Summary of Decisions Requested to Proposed Private Plan Change 11: Bardowie Industrial Precinct by Topic

Sept / 2018

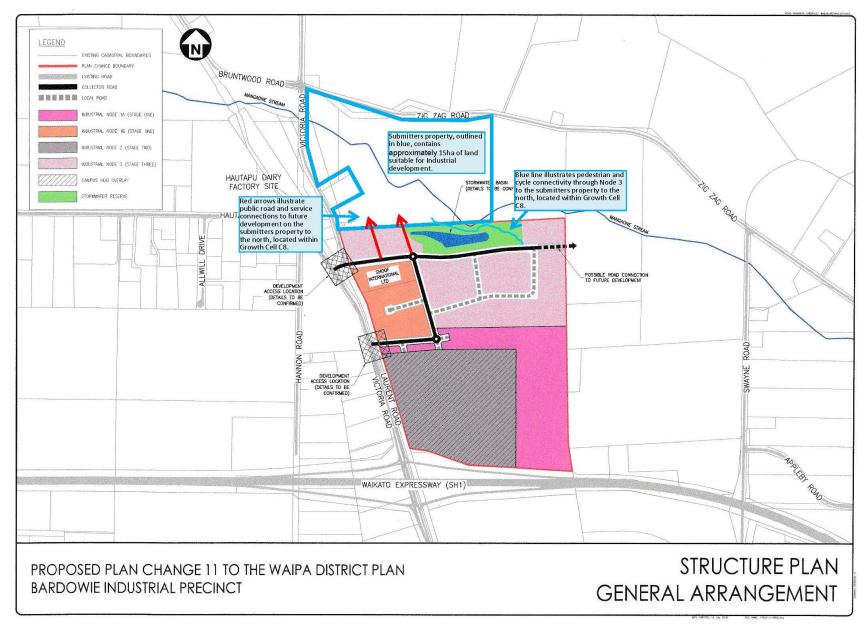
4 Built Form	13/41	Support in part	Seek to protect the amenity (including visual amenity) of adjoining zones and properties.	<ul> <li>Amended to read as follows:</li> <li>BUILT FORM</li> <li>Building Design</li> <li>Design Objectives</li> <li>To reinforce the rural character of the local area through appropriate built form and landscape elements.</li> <li>To provide buildings that facilitate visual interest and variety in form and appearance.</li> <li><u>To provide buildings and structures that are designed to protect the amenity (including visual amenity) of adjoining zones, neighbouring properties and the local environment.</u></li> <li>To provide practical building forms that meet the purpose of the industry or business.</li> <li>To encourage building design that is environmentally sensitive.</li> <li>Design Guidelines</li> <li>4.6 Avoid excessive blank walls,</li> <li>4.7 Large expanses of building walls that are visible from the street <u>adjoining zones, and adjoining properties</u> should be broken up or otherwise detailed to reduce the scale and</li> </ul>
